Sharmin Apparels Ltd. Sharmin Fashions Ltd. Ha-Meem Washing Plant Ltd. Sharaf Apparels Ltd.

08 April 2014

Observations

Main Garment Factory

Repairs to cracking on soffit of 5th floor

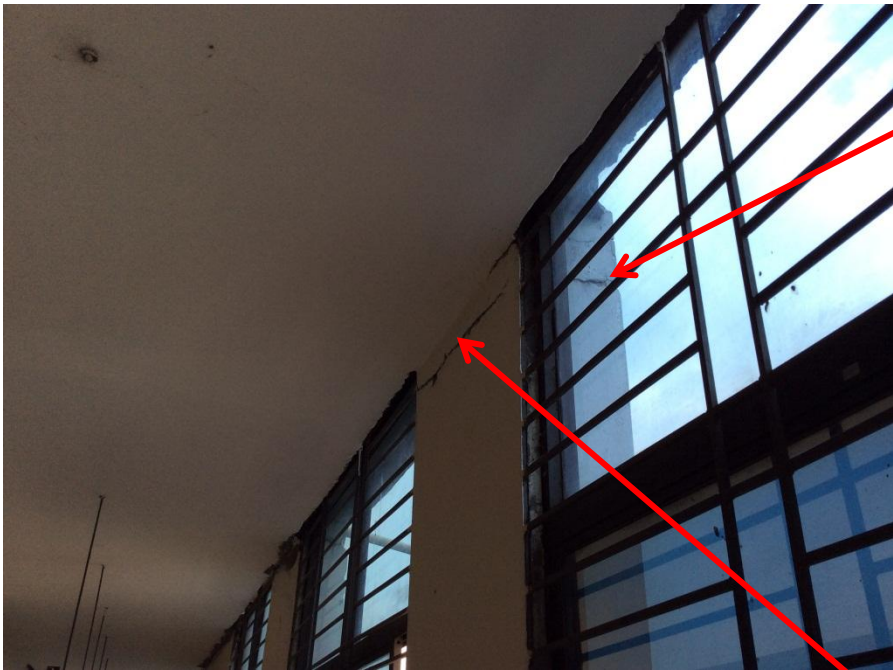
Issues highlighted in BUET Structural Assessment Report

Cracking on ground floor adjacent to column

Building Engineer to carry out a Detail Engineering Assessment including:

- Review of remedial works carried out to date.
- Detailed remedial scheme for any further works, including foundation remedial works, required to ensure that the existing 5 storey building is provided with an adequately robust structural system.
- Documentation of load limitations and preparation of Floor Loading Plans for strict compliance during factory operations.
- Implications of the under-reinforced zones within the post tensioned floor slabs.
- Details of the strengthening works required to the existing structure and foundations if further storeys are to be constructed.

Main Garment Factory - East Elevation

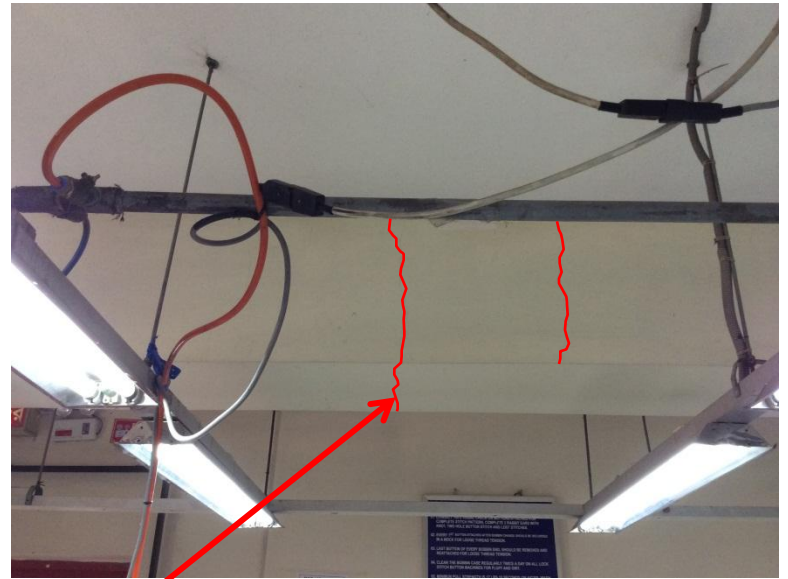
4th floor appears to be deflecting more relative to the 5th floor (roof) causing the pier to separate from the underside of the roof.

**Cracking in the pier
observed throughout**

**Building Engineer to check that the
piers have adequate capacity to
resist lateral loads.**

Cracking in RC Beams

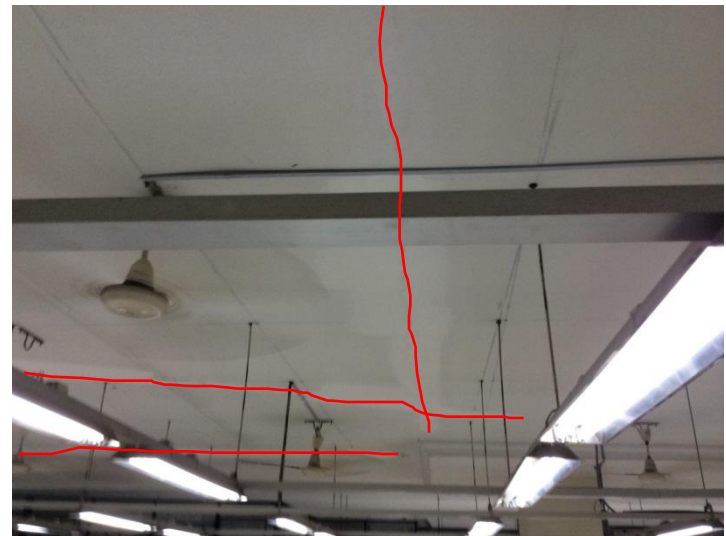
Numerous examples of cracking in RC perimeter beams

Cracking in beams to be reviewed by removing plaster to confirm that cracks do not extend into structure.

Lightweight Roof Construction

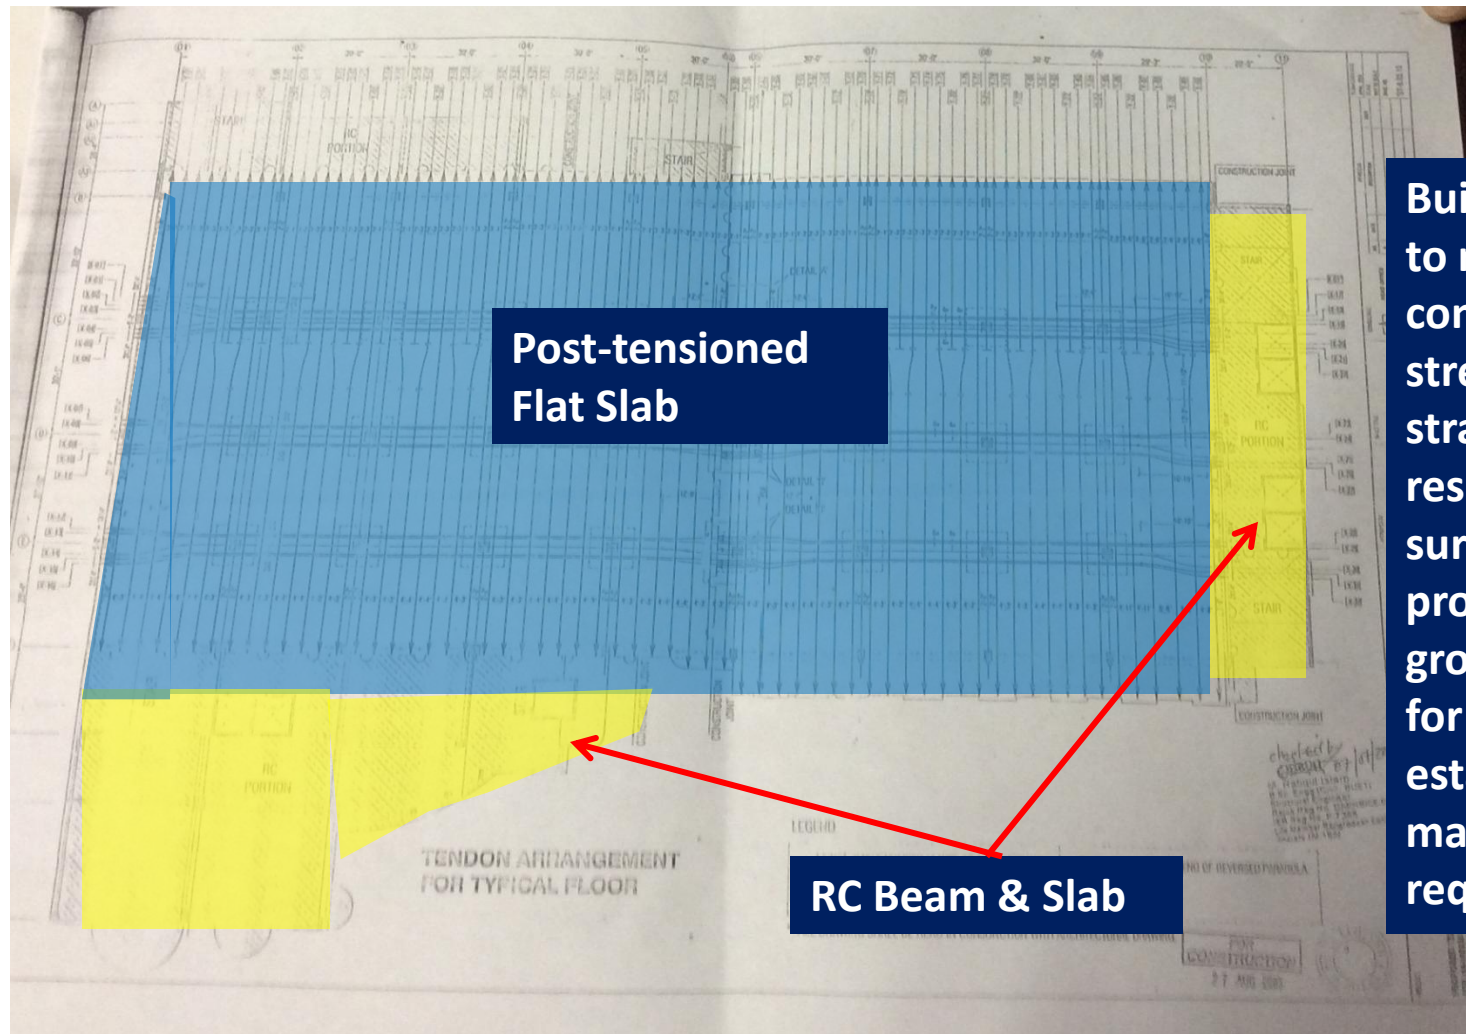
Lightweight steel roof construction to stairs

Lightweight steel roof structure.
Building Engineer to review adequacy of
roof structure to resist high wind loading

P.T Floor Slab – Quality Records

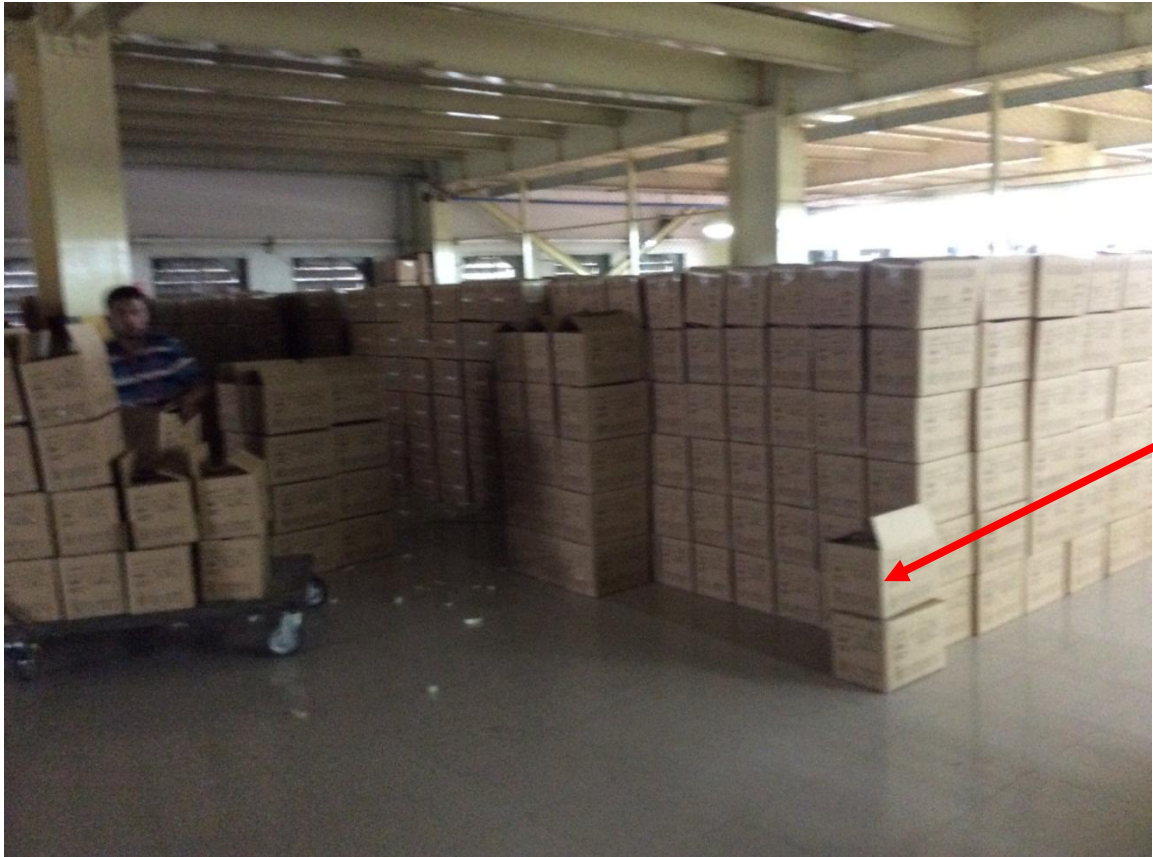
**Post-tensioned floor slab
construction requires a high level
of quality control during
construction**

**Building Engineer
to review
concrete cylinder
strength records,
strand extension
results, as-
surveyed cable
profiles and
grouting records
for PT slabs to
establish if these
match design
requirements**
